MISSISSIPPI RIVER - GULF OUTLET  
LOUISIANA

-----  
DESIGN MEMORANDUM NO. 1-C

CHANNELS

ENGCW-E(7 Apr 61) 2nd Ind  
SUBJECT: Revisions to Design Memorandum No. 1-C, Mississippi River-  
Gulf Outlet

**TYPICAL SECTIONS**

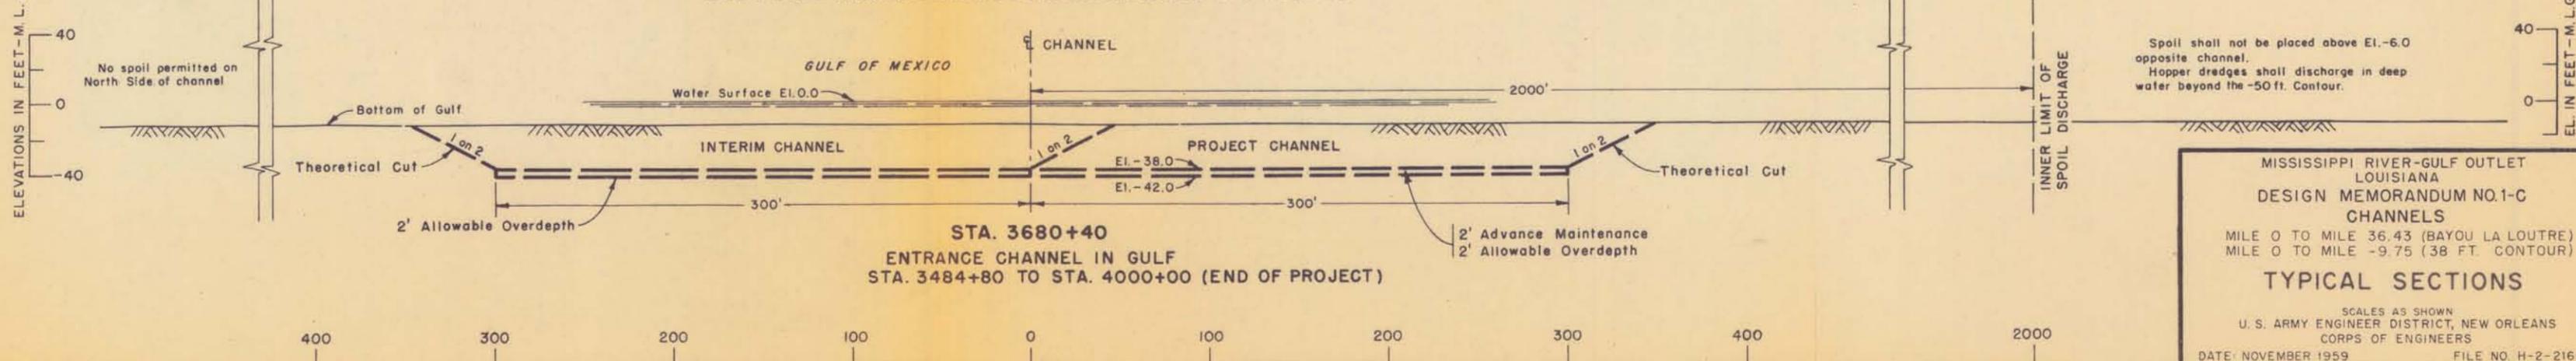
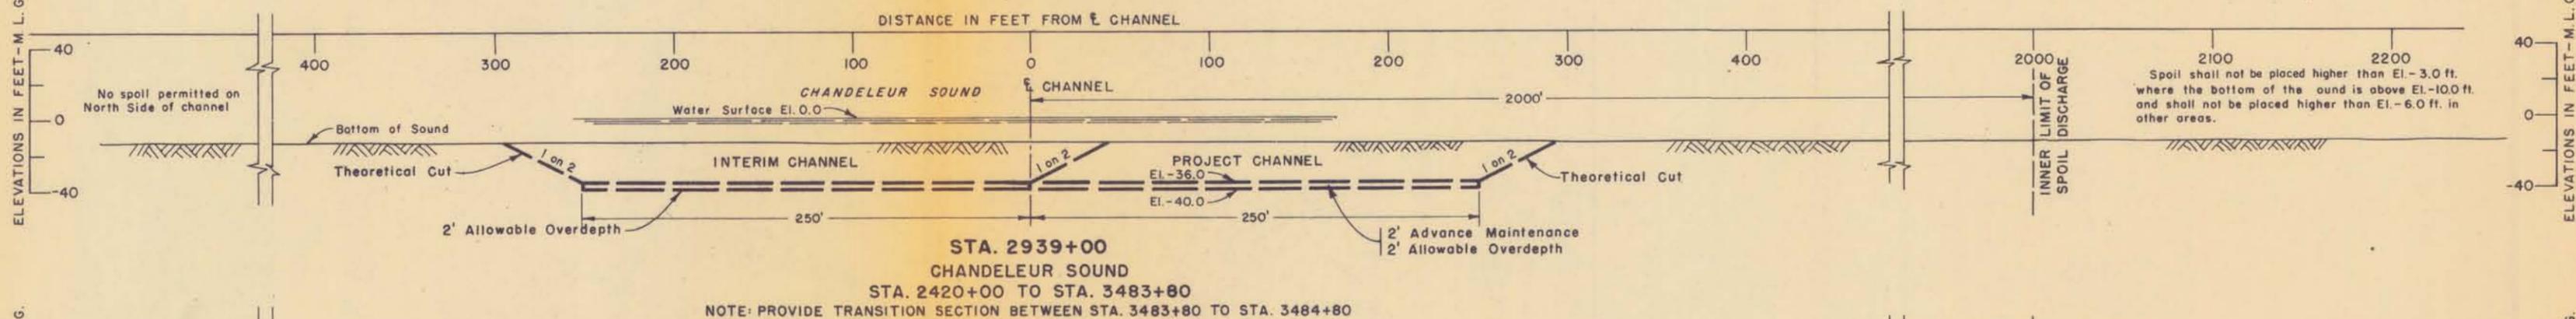
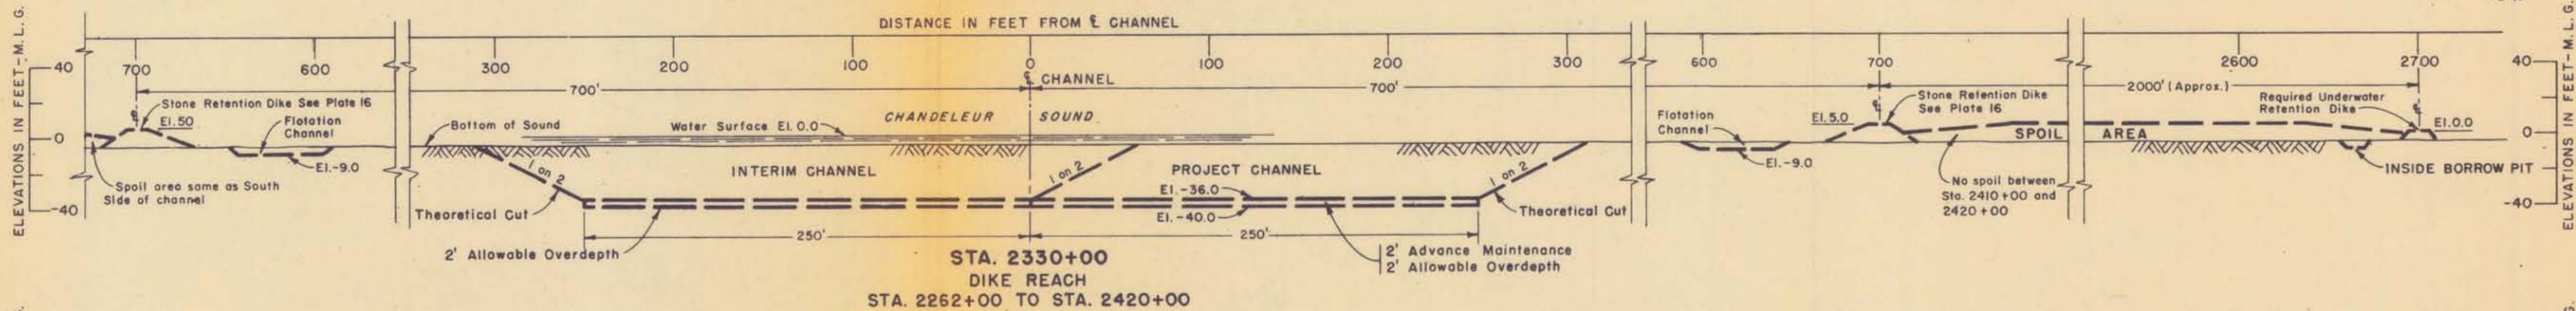
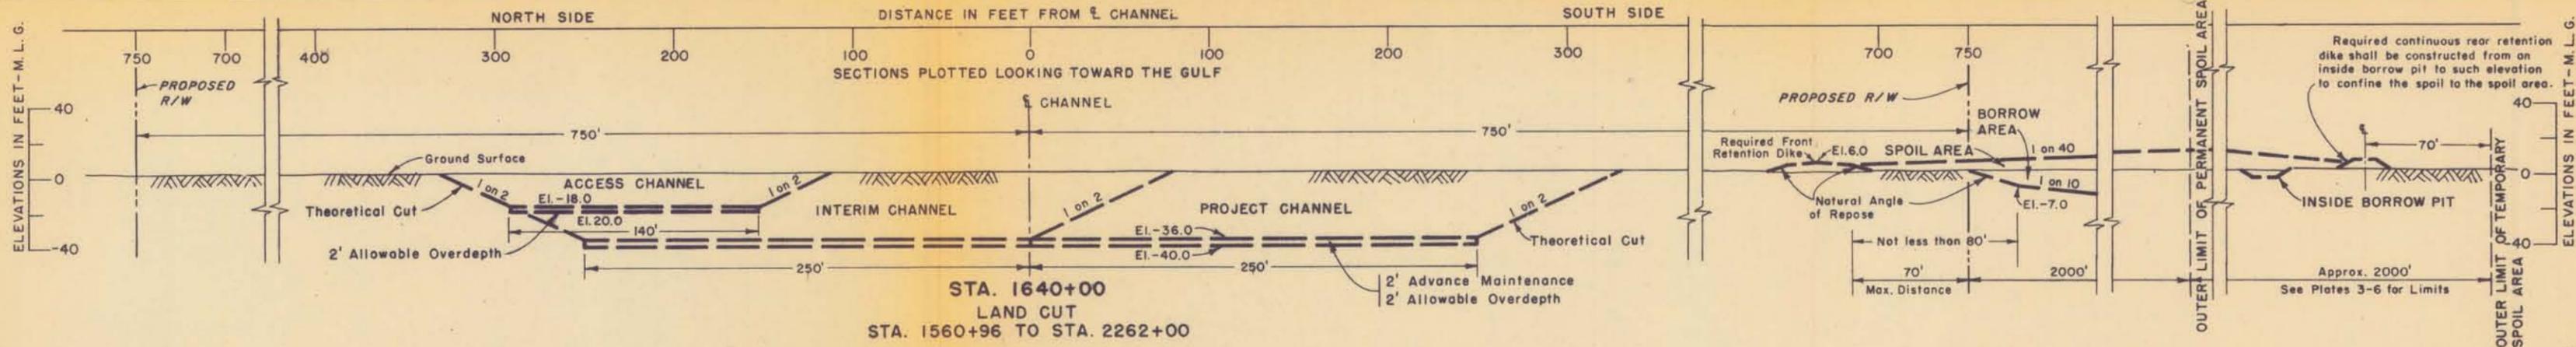
4. The location of the underwater earth retention dikes, referred to in paragraph 5c and shown in cross-section on plate 17, should be indicated on plates 6 and 7.

a. Par 5c, Page 2. During the preparation of plans and specifications, consideration should be given to the elimination of the side and rear underwater retention dikes proposed in lines 12 to 15 and shown on plate 17.
